STAFF REPORT AMENDED 4-11-85  
**CITY PLANNING COMMISSION**

B. Special Permit to develop a 369 unit apartment complex in the Pheasant Creek PUD (Section 8-C-3)

PROPOSAL: The applicant is requesting the necessary entitlements to develop a 369 unit apartment complex on two parcels in the Pheasant Creek PUD to be known as the Stonecreek Apartments.

**EXHIBIT A**

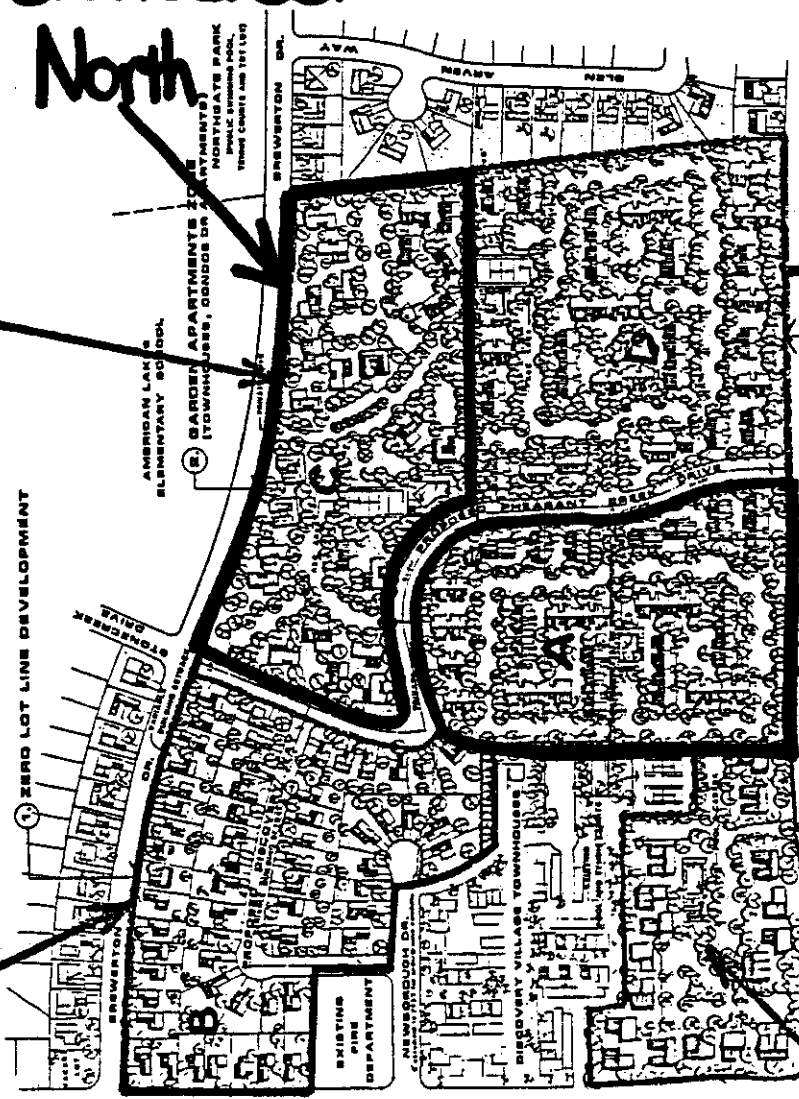
BACKGROUND INFORMATION: On January 10, 1984, the City Council approved the necessary entitlements for the Pheasant Creek PUD (Exhibit A). The residential PUD consists of one 215 unit condominium development (22 du/ac), one 204 unit apartment development (21.7 du/ac), one 170 unit apartment development (21 du/ac) and a 59 unit zero lot line development (6 du/ac). The proposed project is located in a portion of this PUD (see Exhibit A).

# EXHIBIT D

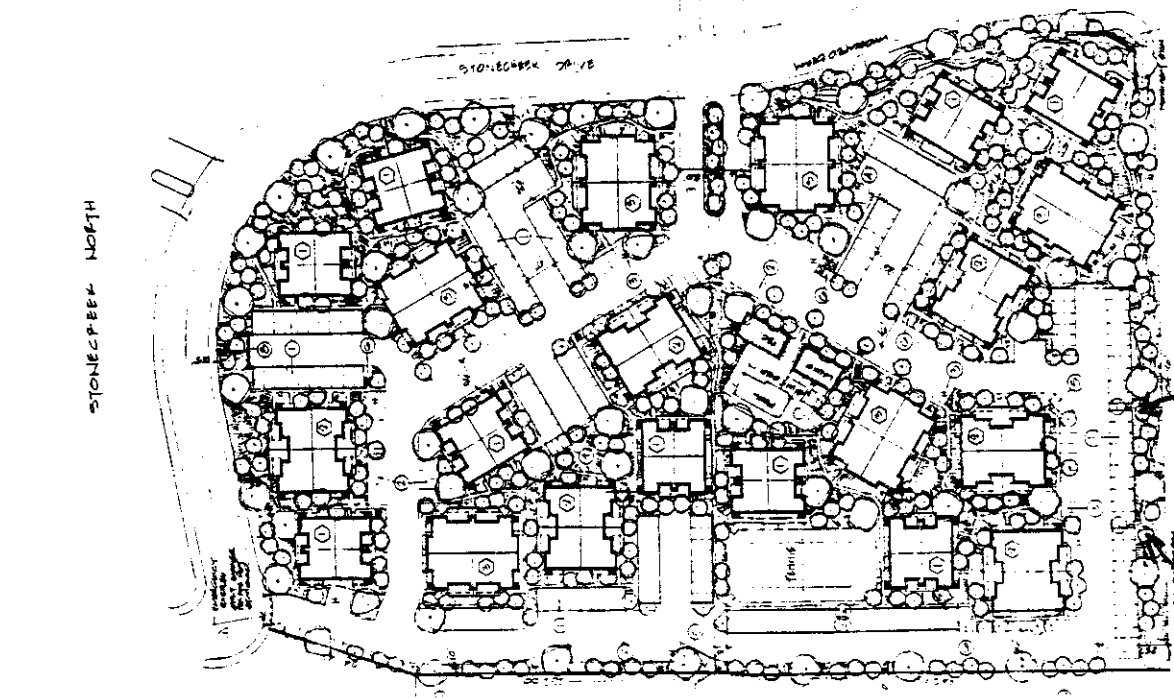
- C. Stonecreek South - Twenty-one (21) two story building clusters are proposed for the project site. All structures are proposed for eight unit clusters (Exhibit D). Recreational facilities include a swimming pool, recreation room and tennis court. Meandering streams and brooks are also proposed.

A 25 foot landscape setback is provided adjacent to Stonecreek Drive and West El Camino Avenue. In order to discourage on-street parking and screen adjacent on-site parking from the street, staff recommends that minimum four foot high undulating berms be required in this landscaped area. Walkways will be prohibited in this required setback.

A minimum 60 foot building setback is indicated from the western property line adjacent to the existing Discovery Village Townhouses. This will provide an adequate noise and visual buffer between the two residential uses. Large evergreen trees should be planted in the 10 foot planter adjacent to the property line to provide further screening. As required by the original PUD approval, the landscape plan for this perimeter planting strip shall be reviewed by the Discovery Village Homeowners' Association prior to issuance of building permits. The applicant has also indicated a six foot high solid masonry wall along this property line. The design and materials of the wall shall be submitted for staff review and approval prior to issuance of building permits.

A portion of the project fronting along West El Camino Avenue consists of carports. These carports should be eliminated or designed with materials similar to the structures (no metal pole or metal trim) and shrubs shall be planted along the carports to create a screening hedge. In addition, the proposed berm along this frontage should be heavily landscaped with evergreen trees.

10. The proposed berm area along West El Camino Avenue shall be heavily landscaped with shrubs and evergreen trees to adequately screen the carports and vehicles.
